**Re: Response to Engineering Submission Comments Feb. 5, 2021  
Overhead Bridge Road, Roll #8-375-05  
Proposed Subdivision and Rezoning Application  
WMI File No.: 20-644**

**Functional Servicing &  
Stormwater Management Report  
Overhead Bridge Road 6 Lots  
Township of Tiny**

**File 20-644  
April 2021**

Figure E3-6

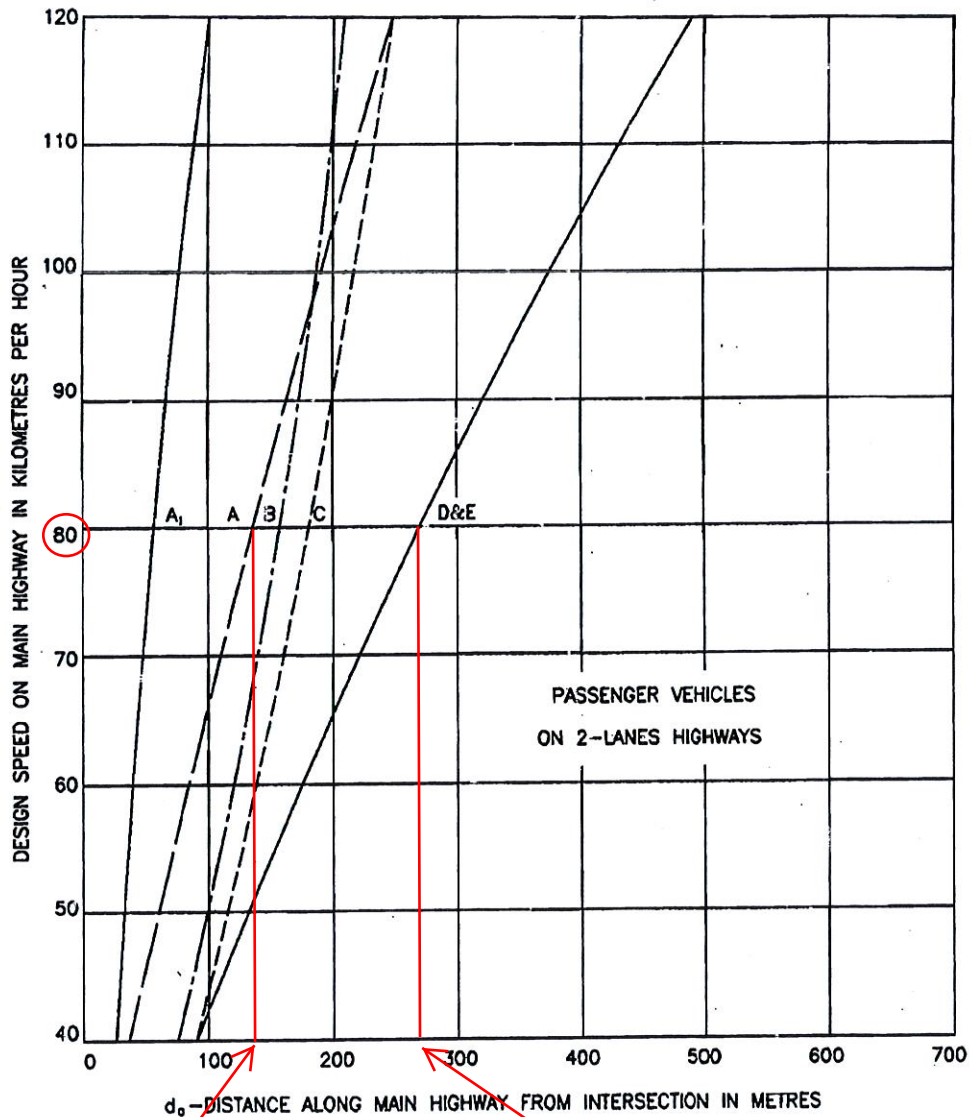
4. The relatively tight radius of the curve just south of Concession Road 12 (radius is approx. 200m) is characteristic of a design speed in the range of 70-80km/h, based on minimum horizontal curve radii information provided in TAC and MTO geometric design guidelines. As such, it is our opinion that a design speed of 80km/hr is appropriate on the basis of determining safe sight-distances, despite the arterial designation of Overhead Bridge Road (a design speed of 90 km/hr would require a radius of +/- 380m). Note that the previously provided sight-distance analysis from Lot 6 was in error, since this driveway is proposed off of Concession Road 12. From a development standpoint, the critical sight-distance analysis measurement should therefore be from Lot 5, as such, this is what is included in the revised Report. The updated sight-distance measurement from Lot 5 is estimated to be 325m, which is in excess of the recommended minimum of 270m for the 80km/h design speed, and is also is approximately equal to the 320m sight-distance for a 90km/hr design speed. We note that the sight-distance calculation for the 90km/h design speed is not explicitly provided in the report since our opinion is that analyses for this design speed is not appropriate for this situation.

The actual critical sight-distance would be from the Concession Road 12 and Overhead Bridge Road intersection, however this is not impacted by development since it is a pre-existing condition. The existing sight distance from this intersection would be less than the condition D and E sight distance of 270km/hr, but it would be in excess of the minimum stopping sight distance (Condition A). The sight-distance can be considered sufficient based on meeting the minimum criteria, however decisions regarding the safety of an existing intersection and the appropriateness of controlling measures such as posted speed limits, warning signage, warning signals, lighting, etc. should be based on collision history and other operational factors. Further to discussions with the Township, we have also added a section on design speed.
